## DEVELOPMENT APPLICATION ASSESSMENT REPORT

<b>Application Number:</b>	DA2020/0190
<b>Responsible Officer:</b>	Maxwell Duncan
<b>Land to be developed (Address):</b>	Lot 14 DP 30742, 10 Woodside Grove FORESTVILLE NSW 2087
<b>Proposed Development:</b>	Construction of a dwelling house
<b>Zoning:</b>	Warringah LEP2011 - Land zoned R2 Low Density Residential
<b>Development Permissible:</b>	Yes
<b>Existing Use Rights:</b>	No
<b>Consent Authority:</b>	Northern Beaches Council
<b>Land and Environment Court Action:</b>	No
<b>Owner:</b>	Belinda Jody Gordon Grant Geoffrey Gordon
<b>Applicant:</b>	Better Built Homes Pty Ltd
<b>Application Lodged:</b>	28/02/2020
<b>Integrated Development:</b>	No
<b>Designated Development:</b>	No
<b>State Reporting Category:</b>	Residential - Single new detached dwelling
<b>Notified:</b>	20/03/2020 to 03/04/2020
<b>Advertised:</b>	Not Advertised
<b>Submissions Received:</b>	0
<b>Clause 4.6 Variation:</b>	Nil
<b>Recommendation:</b>	Approval

The development application seeks approval for construction of a two storey dwelling house with double garage and associated landscaping. Not demolition is proposed under this application.

Image 1 - Building Height Calculation

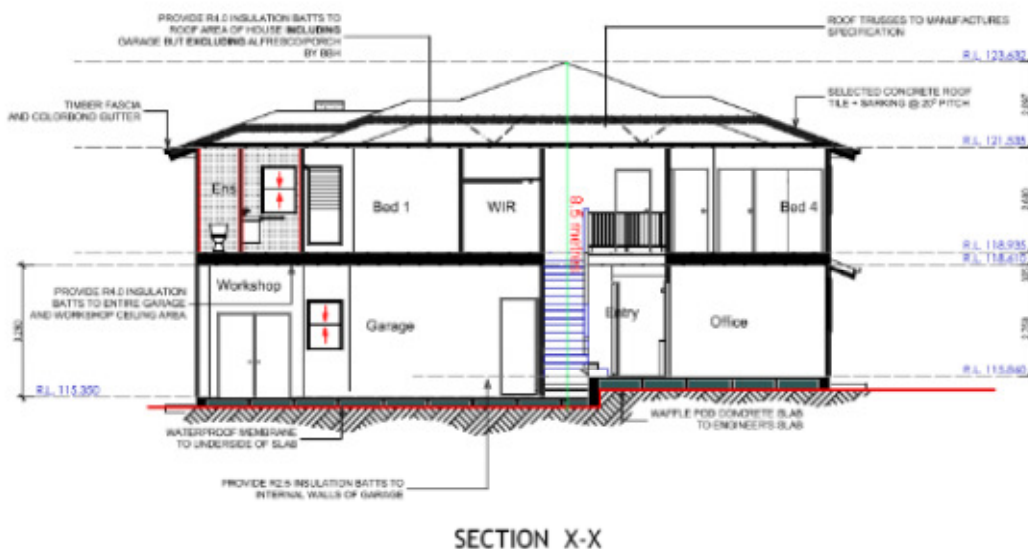
Standard	Requirement	Proposed	% Variation	Complies
Height of Buildings:	8.5m	8.5m	-	Yes

Clause	Compliance with Requirements
2.7 Demolition requires consent	Yes
4.3 Height of buildings	Yes
5.3 Development near zone boundaries	Yes
5.8 Conversion of fire alarms	Yes
6.2 Earthworks	Yes
6.4 Development on sloping land	Yes
